Origination Form
Proposed Revisions to a Standard Plans Index

Originator:	Meyer, Ronald	Index Number:	653-001
Date:	6/18/2025	Sheet Number(s):	1 of 1
E-mail:	Ronald.Meyer@dot.state.fl.us	Index Title:	PEDESTRIAN CONTROL SIGNAL INSTALLATION DETAILS

PEDESTRIAN CONTROL SIGNAL
INSTALLATION DETAILS

INDEX
653-001

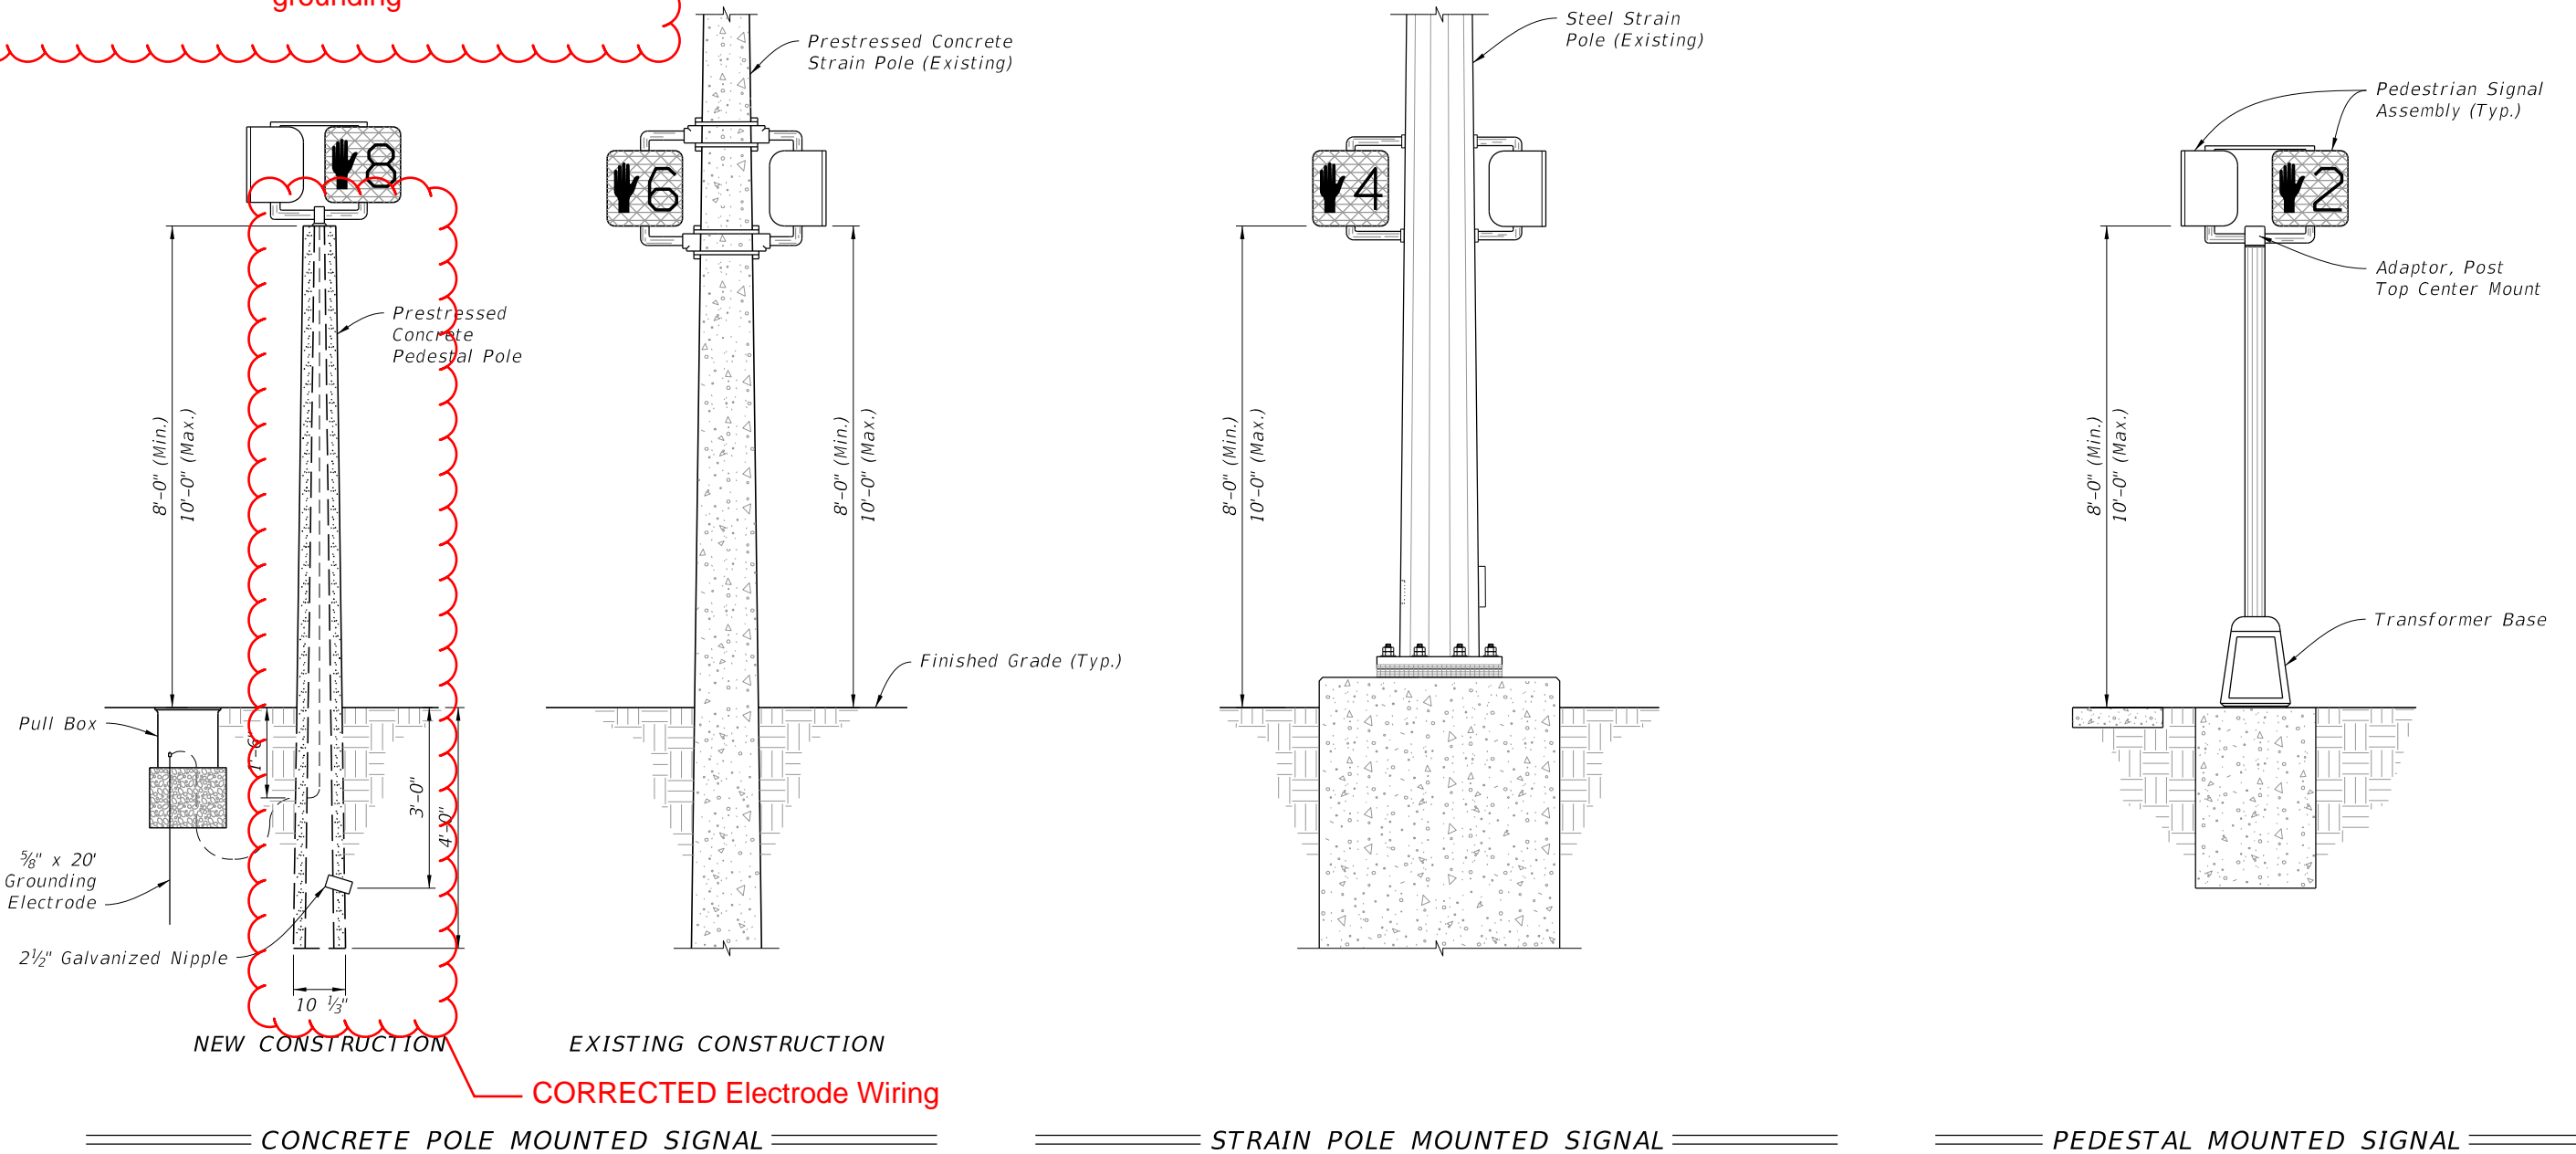
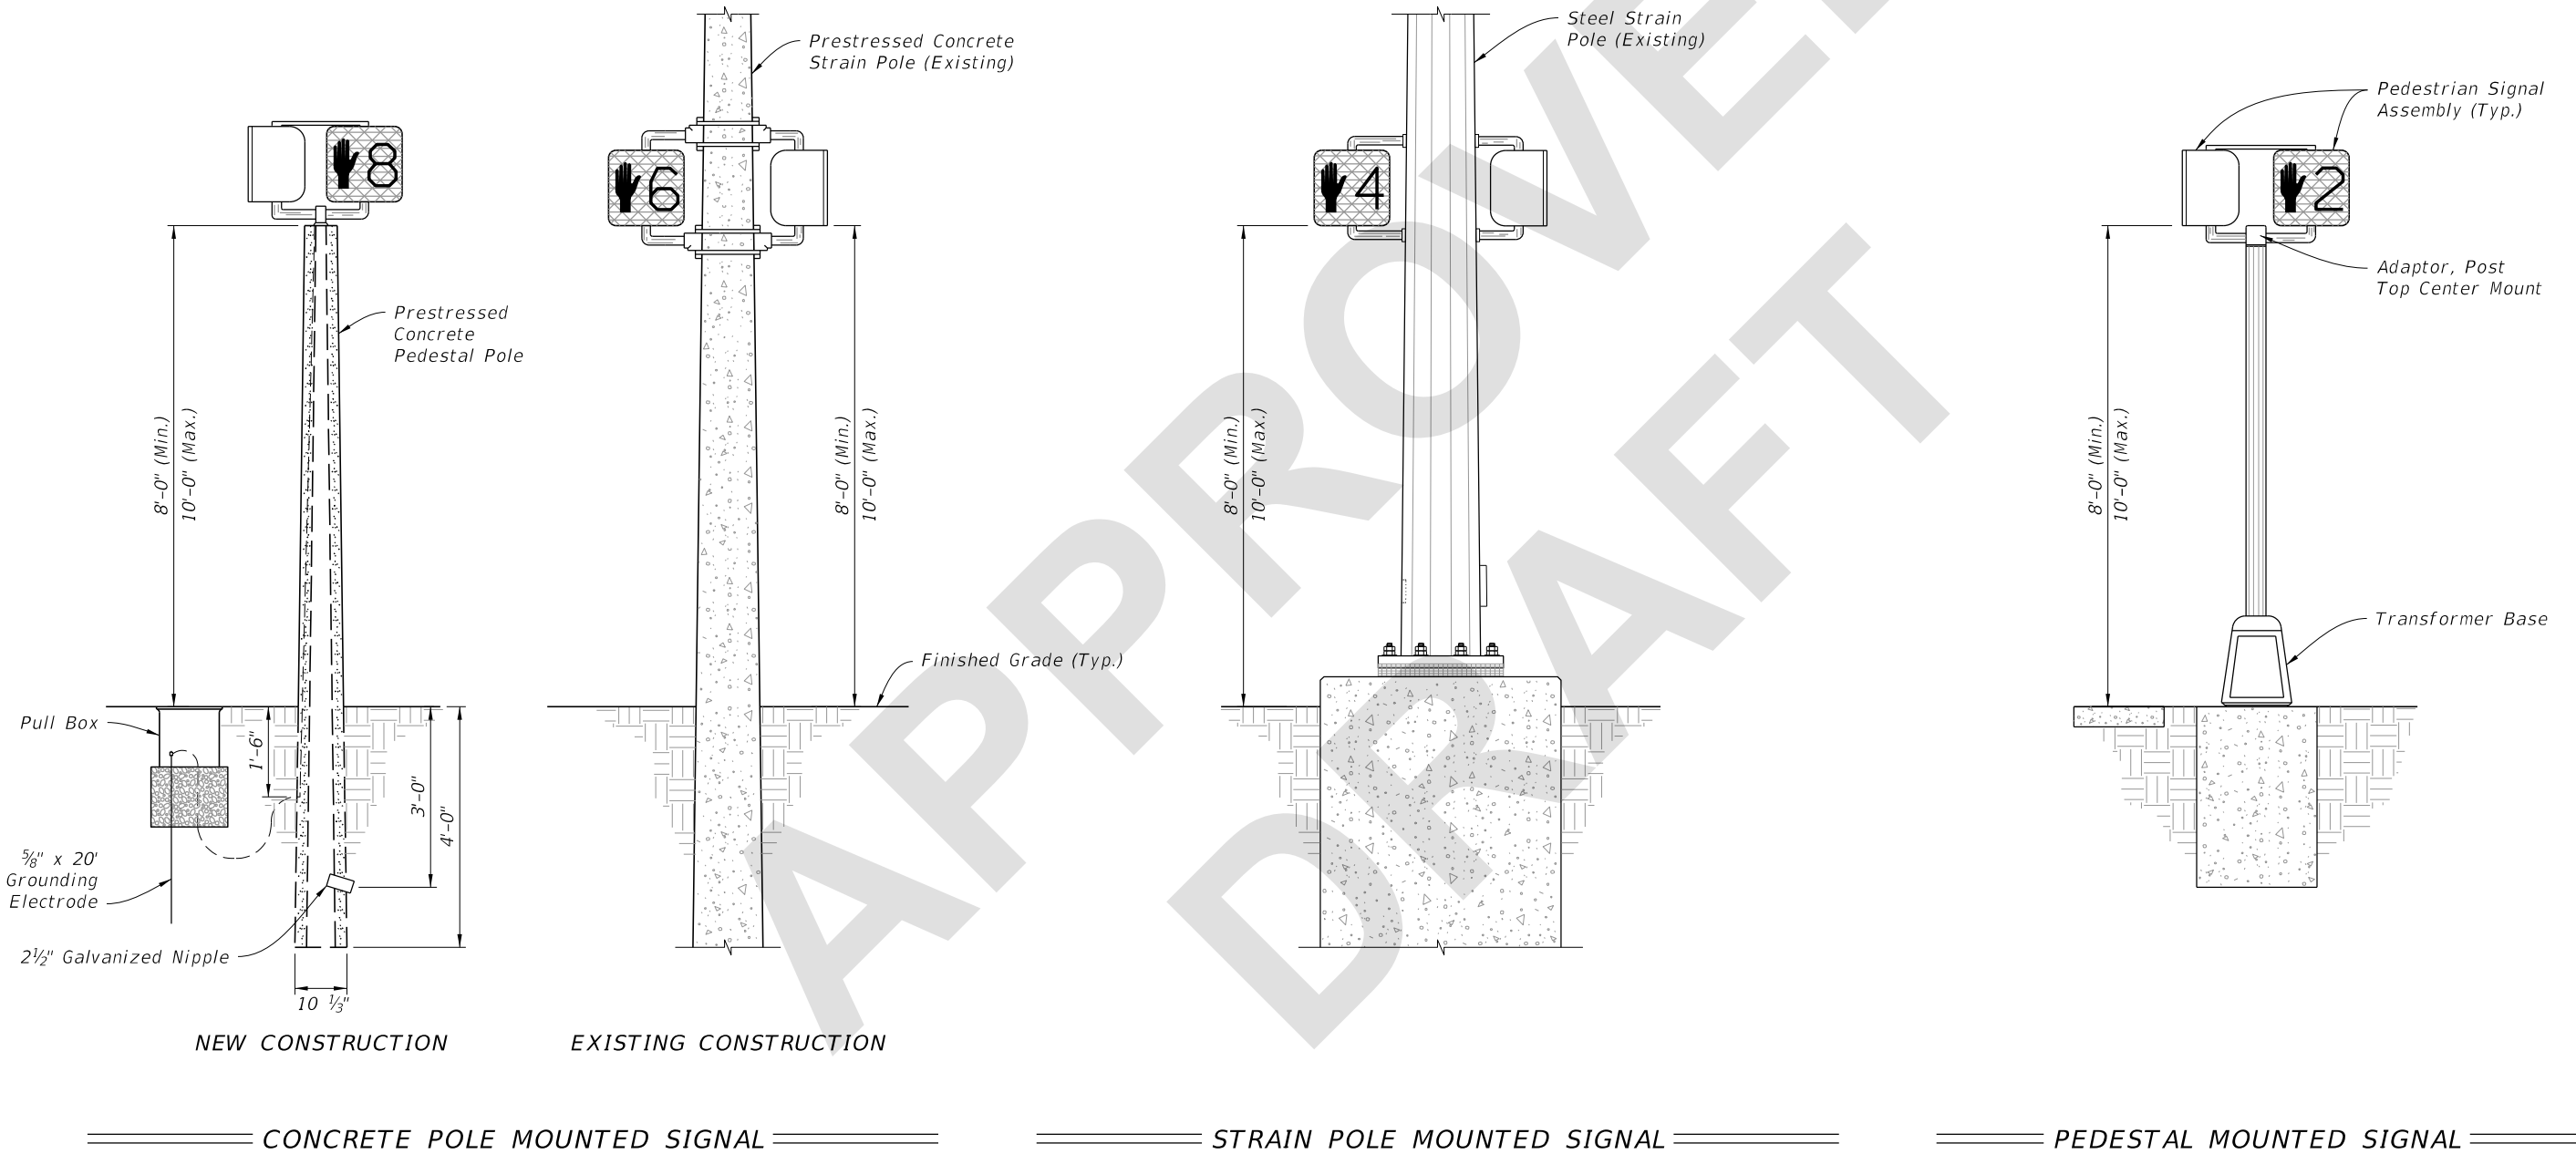
Sheet 1: Corrected wiring in Concrete Pole New Construction detail; Added "grounding" to Note 7

The TERL has received multiple questions from Contractors regarding clarification of grounding requirements for pedestal poles. This update is to help clarify requirements to reduce future questions. Corresponds with Specification update to 620-3.3.

posts, foundations, and grounding

1. As an option, pedestrian signals may be installed on concrete poles and pedestals using lead anchors (two bolts same size per hub) in lieu of the stainless steel bands.
2. Repair drilled or punched holes in galvanized steel poles or pedestals in accordance with Specification 562. Install grommets or bushings in each hole.
3. Meet grounding requirements of Specification 620.
4. See APL for Department-approved Pedestrian Signal Assemblies and hardware.
5. For Prestressed Concrete Poles see Index 641-010.
6. For Steel Strain Poles see Index 649-010.
7. For Pedestal Mounted Signal posts, foundations, and grounding, see Index 646-001
